3.1 AESTHETICS

Harvard-Westlake Parking Structure ■

Figure 3.1-26

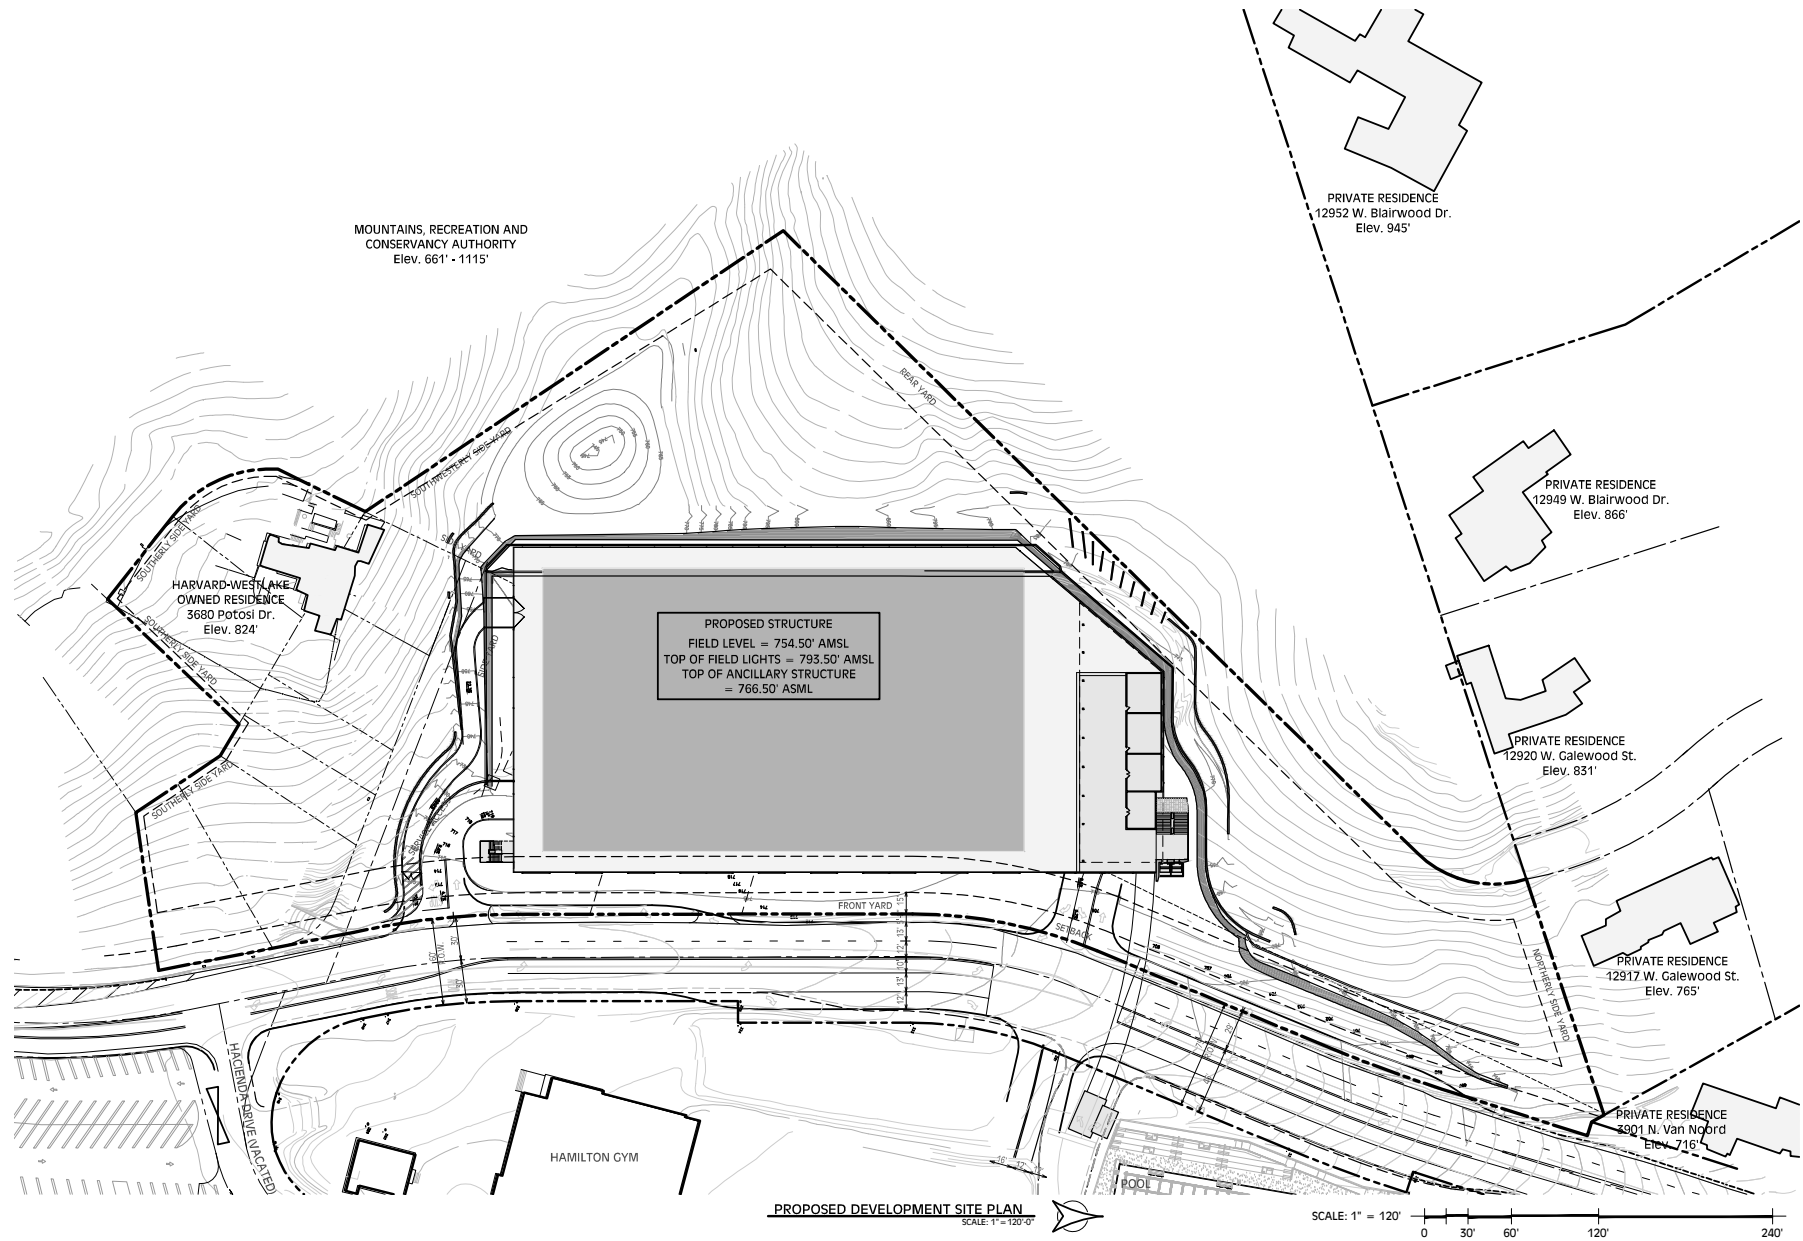
The Proposed Project would include ~~vegetation~~ new landscaping and permeable area, or be undisturbed site except for planting new native vegetation/mitigation trees on approximately 63.98 percent ~~60%~~ of the Development Site (see **Figure 3.1-26** below). The maximum proposed building footprint, ~~or maximum lot coverage~~, for the Parking Structure would be approximately 28.12 percent ~~35.1%~~, plus an additional approximate 4.69 percent ~~4.5%~~ of hardscape areas and 3.21 percent ~~%~~ occupied by a vacant residence at 3680 Potosi Avenue and associated hardscape. Approximately 33.55 percent ~~39.9%~~ of the Development Site would be undisturbed Development Site except for planting new native vegetation/mitigation trees ~~remain in its existing vegetated state (except that new trees would be planted in this area to replace Protected Trees removed by the project on other areas of the site)~~, and approximately 30.43 percent ~~20.5%~~ of the Development Site would be new drought tolerant landscaping and permeable area. ~~newly landscaped using native vegetation.~~

Figure 3.1-29
Lighting Fixture Specifications

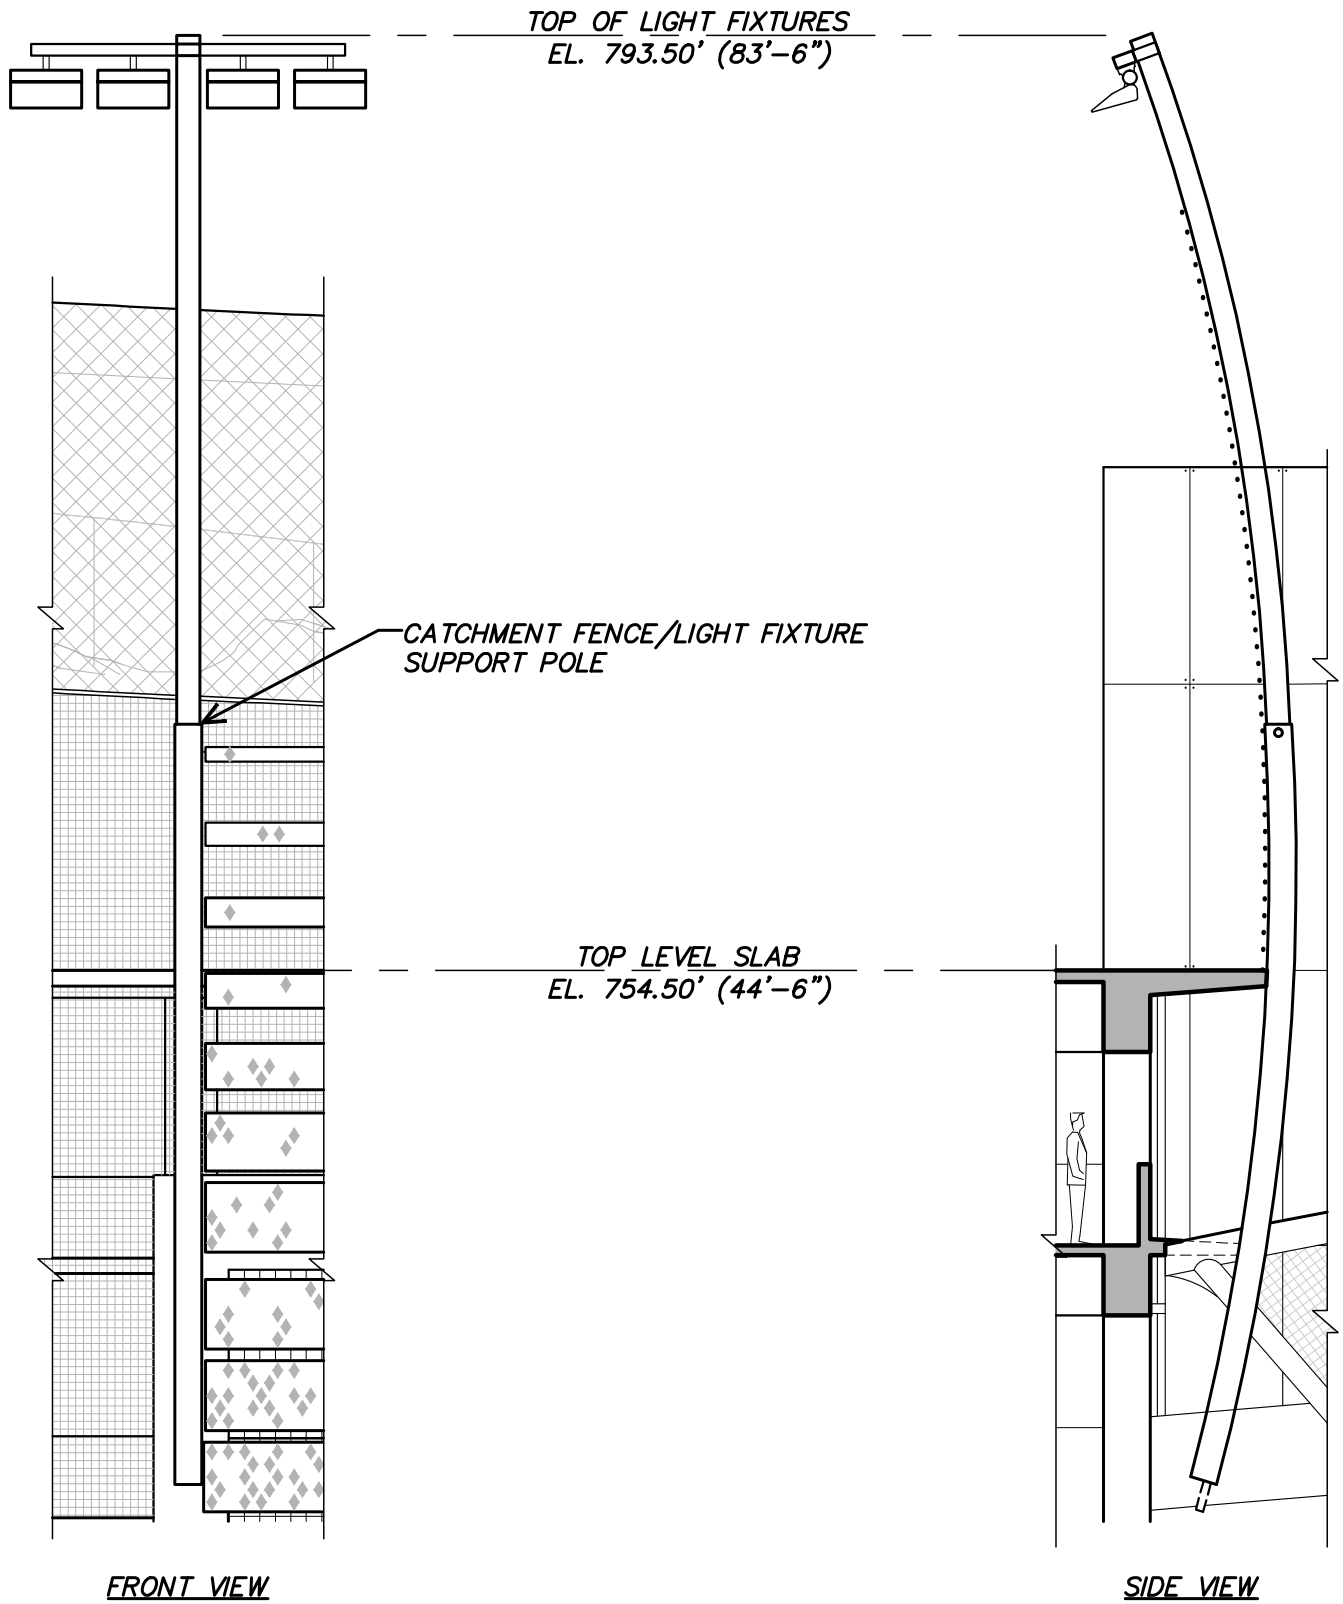
A lighting plan has been prepared (see **Figure 3.1-29**), including ~~40~~ 14 light poles (~~five~~ seven on each side of the field) each with ~~two to three~~ four LED fixtures per pole. Light poles would extend approximately 39 feet above the field level (up to approximately 84 feet above ground level; or approximately 794 feet AMSL) and would be painted green to blend with the surrounding foliage.

Musco assumed ~~five seven~~ poles per side with ~~two to three~~ four LED fixtures per pole. The plan also assumed the use of Musco's ~~long visors~~ light shields on all their fixtures to direct the light downward onto the playing surface while cutting off light as much as possible outside of the field. Each fixture would be individually aimed to optimize light on the field of play while at the same time minimizing spill and glare. While a different lighting system could be used, the analysis presented herein assumes that the plan prepared by Musco represents a reasonably conservative plan for purposes of analysis of spillover lighting.
